Remarks

S.N. 10/028,663

AMENDMENTS TO THE DRAWINGS

Fig. 1

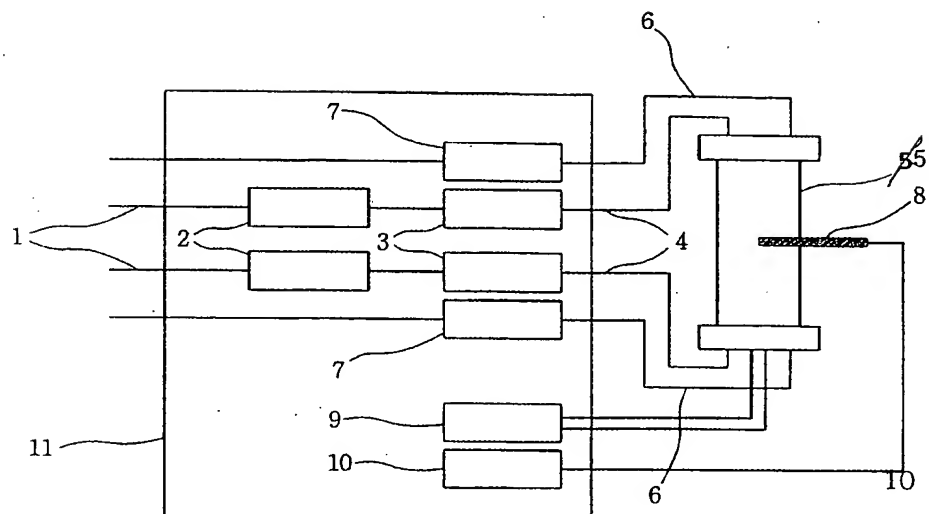
The drawings stand objected to regarding informalities noted in sections 1 and 2 of the Office Action. The Specification has been amended to correlate the reference numbers used in the drawings with the Specification.

Fig. 1 has been amended to replace reference numeral "55" with "5" as marked in red. Replacement drawings are attached hereto.

Please replace drawing sheet [0011] including Figs. 1 and 2 with the amended sheet attached hereto. An annotated sheet showing the change made is also attached.
